6951 Carroll Avenue, Takoma Park
HPC Case No. 37/03-0855
Takoma Park Home District

SUBJECT: Historic Area Work Permit #489519, Reconstruct privacy fence around new HVAC unit.

Staff Item

Address: 6951 Carroll Avenue, Takoma Park
Takoma Park Seventh Day Adventist Church
Takoma Park Historic District

New Proposed Condition, 14 January, 2009. (9)

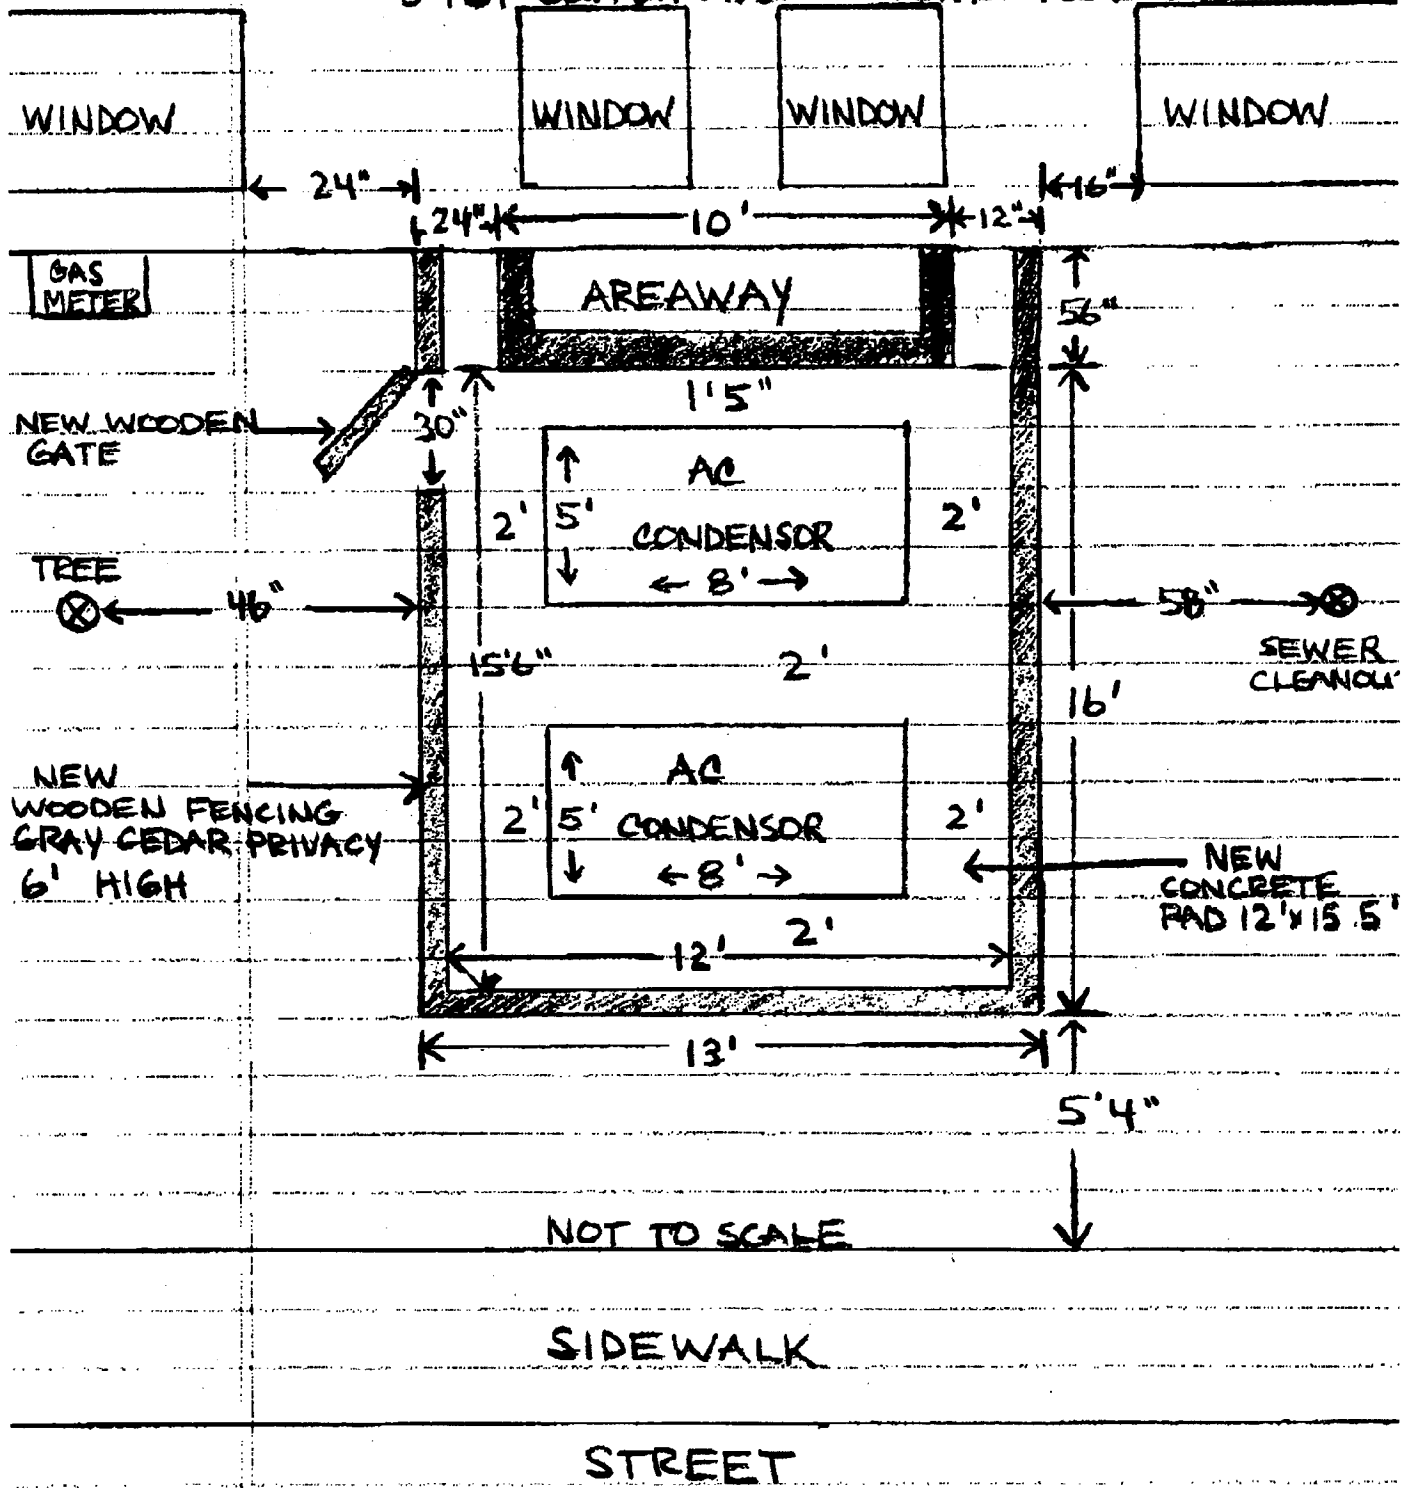
New Proposal: The applicant is proposing to install two smaller HVAC units and therefore will need to alter the dimensions of the approved enclosure. The applicant now proposes to lower the height of the proposed fence to 6' tall, the width of the enclosure would also change from 18' wide to 12' wide, and the length of the enclosure would increase to within 5'4" of the sidewalk from the original 9' from the sidewalk. The drawings attached show the existing condition, the proposal approved on 23 July, and the new proposed condition. No other formerly approved detail will change in the new proposal.

Basically, the applicant turned the enclosure around 90 degrees to be parallel w/ the church wall rather than perpendicular to it. This change ~~to~~ increases the distance of the enclosure from the sidewalk.

Approved Proposal - 14 Jan 2009

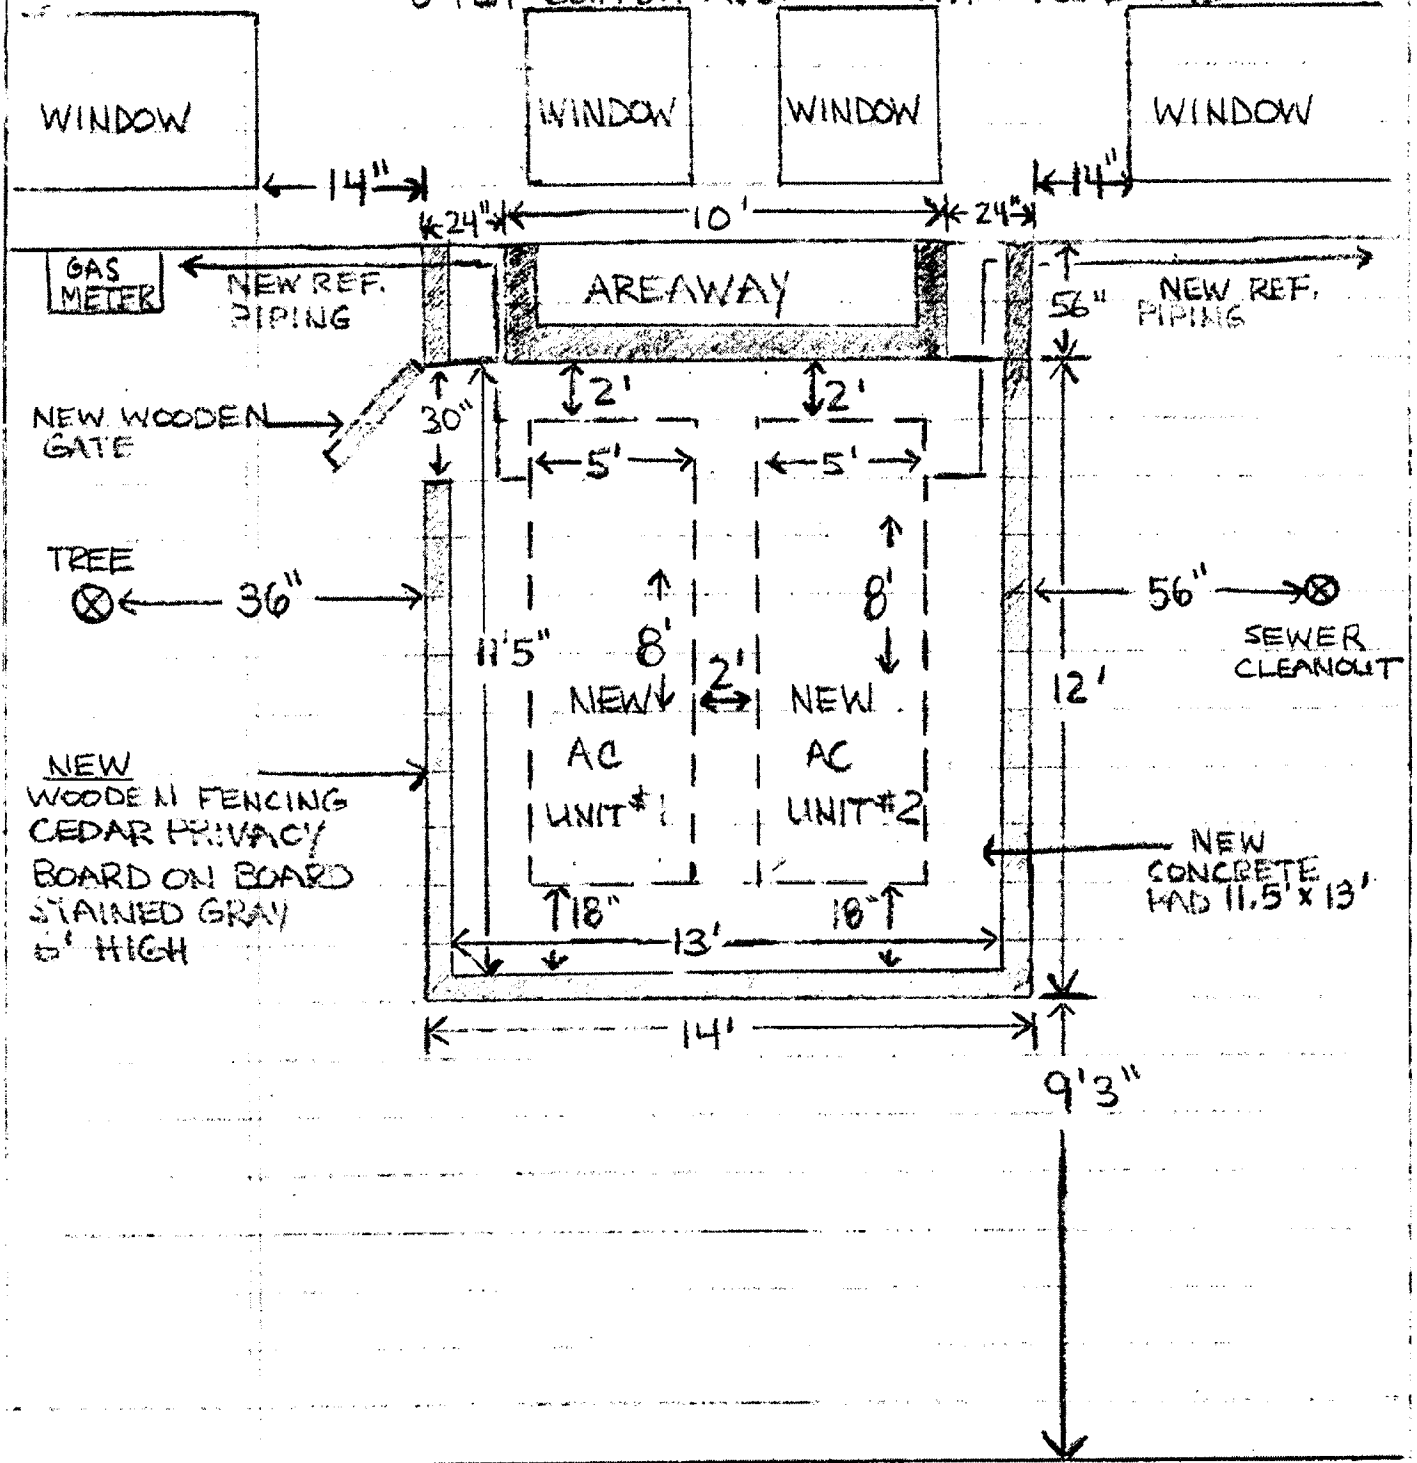
This staff item was altered based upon communications earlier in the day. ^{at the meeting} The current configuration is on page 5 of this document.

Rachel, City of Takoma Park approved all proposed work last night with 1 stipulation: New concrete pad and fencing be turned sideways instead of longways coming out from Church wall. They would not allow structure to within 9' of sidewalk. This goes back to option 2 drawing which I sent you previously. My assistant is emailing you all info with new drawing showing new equipment locations. Everything else stays the same. New pad will be somewhat smaller so no additional windows will be blocked. New pad will be 13' wide by 11'5" long(out from Church wall) with 6' wooden cedar privacy(board on board) fencing around pad. Let me know how meeting goes tonight. I have also sent letter to Todd Bolten for Tree Protection Permit. He states that as long as we stay within guidelines we will not need permit. I will have my cellphone on tonight if you need me to answer any questions at meeting. 301-440-4927. Thanks.

- 1) that the air handling units be rotated 90 degrees from that submitted; and
- 2) that there be a 9 (nine) foot clearance between the Laurel Avenue sidewalk and the finished wall rather than the five foot four inches shown; and
- 3) that the fence be finished with a grey stain; and
- 4) that the access to the equipment be located on the side of the fence perpendicular to the church wall or if on the side facing the sidewalk, as a removable panel.

EXISTING EQUIPMENT DRAWING

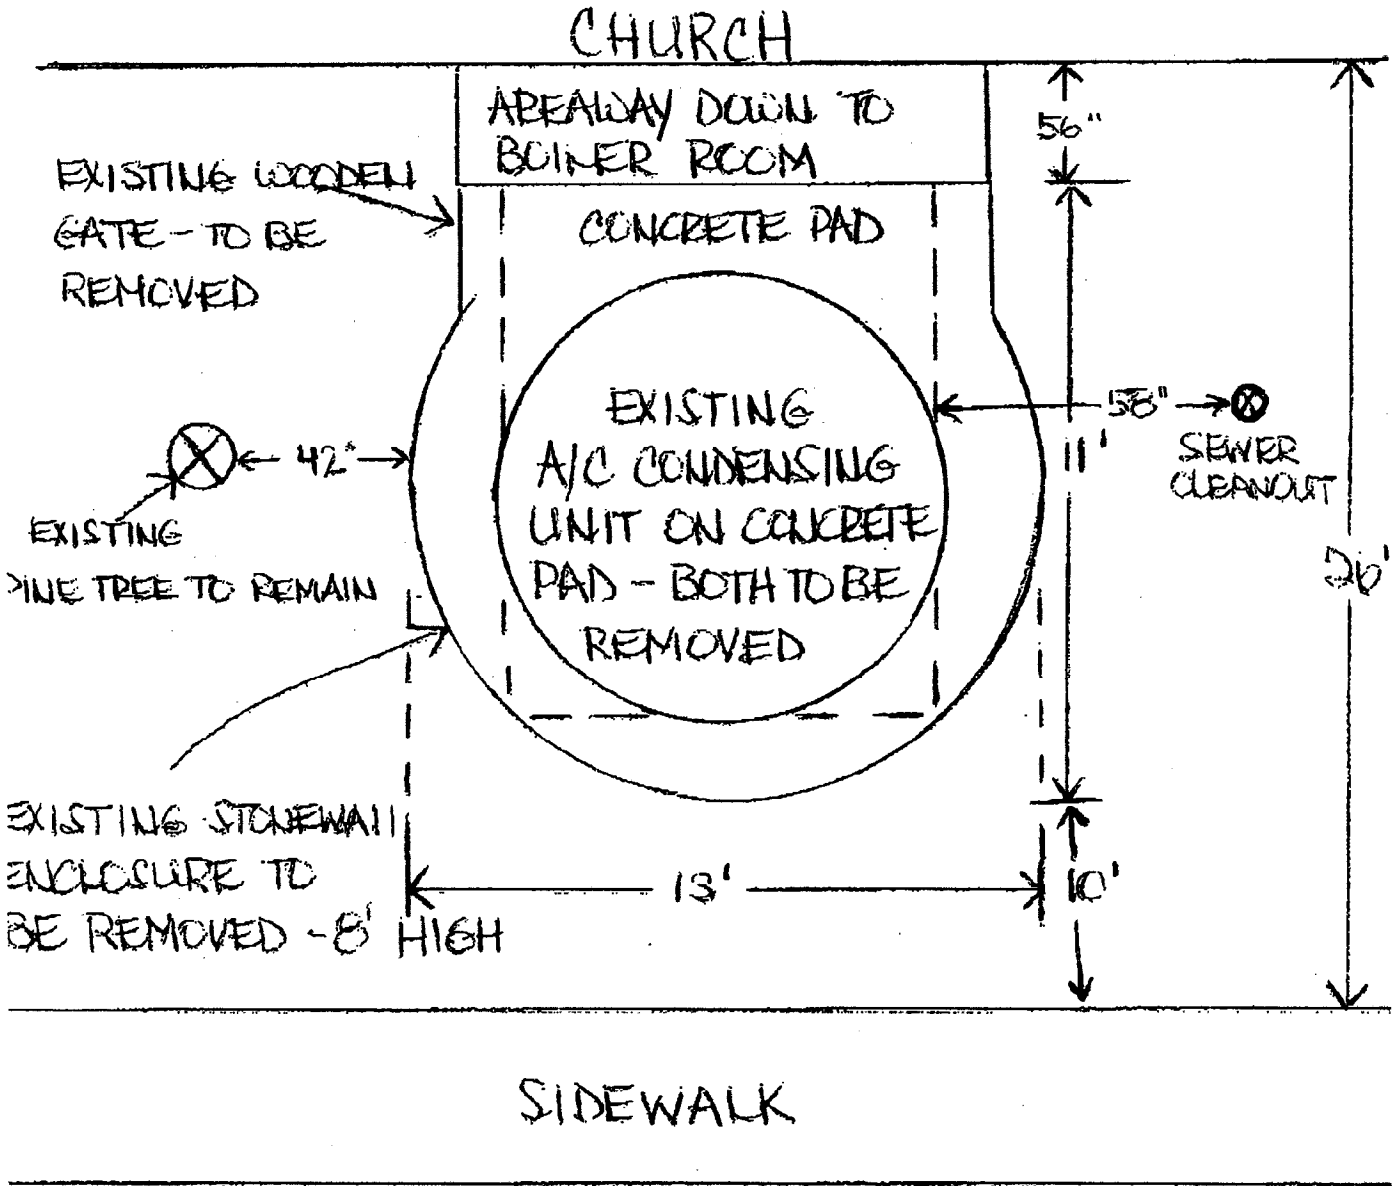
Re question 6: the drawings show the areaway directly behind the proposed wood enclosure. The areaway appears to be about 2-3 feet from the current stone enclosure. This leads me to the question: are you moving the location of the enclosure? Or are you enlarging it to include the areaway? ,Se the photo I have attached. The areaway I am talking about is directly to the right side of the stone fence with the round stone thing resting on it in the photo..

- 6) There is an iron fence covering what I thought was an areaway directly adjacent to the current enclosure? Is this what you are referring to as an areaway? If so, are you planning on relocating the enclosure? (this feature is close to the current condenser unit).

Sorry, I made a mistake, distance from church wall to end of enclosure for option 2 is 17', and option 1 is 21'. Areaway that I am talking about is directly behind wooden enclosure, it is a bricked out pit under widows that goes down below grade into boiler room. Area way that you are talking about to right of enclosure will remain untouched. Stone thing in the middle is a ac condensing unit, that will be relocated to inside of new wooden enclosure so public will not see anymore. We were talking about 2 diferent things. My areaway is basically a pit that allows fresh air down into mechanical room. It is a bicked out enclosure from church wall under widows, it is only about 12" high, comes out 56" from church.

PROPOSED NEW EQUIPMENT LOCATION
(OPTION #1)
CHURCH

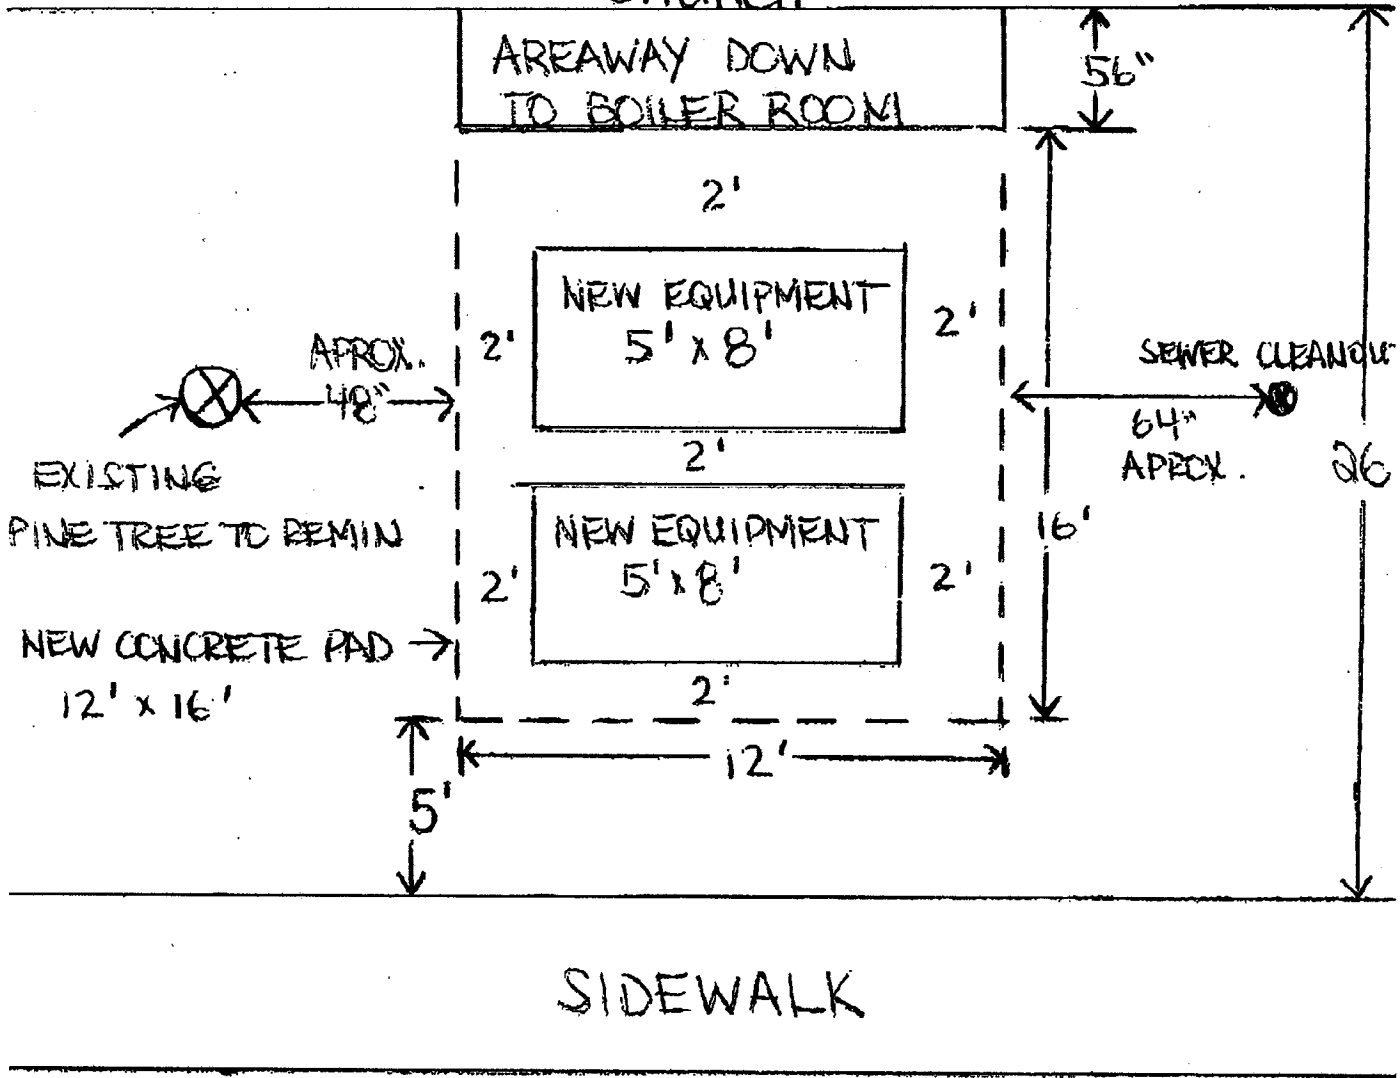
I will bring this to the HPC as a staff item on 14 January. (You do not need to be there). I do not foresee any problems. The changes to the application I will ask for are: two smaller units, 6' tall enclosure (they will love this), 12' wide rather than 18' wide enclosure, and unit enclosure will extend to 5' of sidewalk, rather than 9 feet. Does this get it all?

I do want to clarify two things beforehand. Can you send me the option one drawing again with the access door drawn on it? Also, the areaway has to be 60" not 56", because that would not equal 26 ft. 56 inches ends up being 4.66666 feet, which cannot be the case. Anyway, if you could resend me the drawing we are good to go. I will get back with you on 15 January to let you know of the verdict.

Thanks. Re question 5: option one is 21 feet and option 2 is 9 feet, really?

- 2) Where will the access door be into the enclosure? I did not see it on the drawing.
- 3) The previously approved HAWP specified hand excavation around the enclosure, due to the presence of mature trees. In addition, it specified consultation with the Takoma Park arborist. Is this still the case?

1. New units are 5'9" tall, so we could install a 6' high fence around equipment instead of 8". Access door in enclosure will be in same location as existing, on left side of fencing where fence meets areaway. 3. All excavation will be hand dug and we will consult with Takoma Park Arborist before any work is done. 4. Enclosure would not be attached to Church but would abut against it same as existing. 5. Measurement from wall of church to end of enclosure: Option 1 - 21', Option 2 - 9'. 6. Existing iron fence is yes covering what I am referring to as areaway. That iron fence will remain, it currently has 2 small ac condensers sitting atop it which service other areas of church. These will remain to be enclosed in fencing obscured from public eye. 7. We will use same type fencing that was already approved. Merry Christmas.
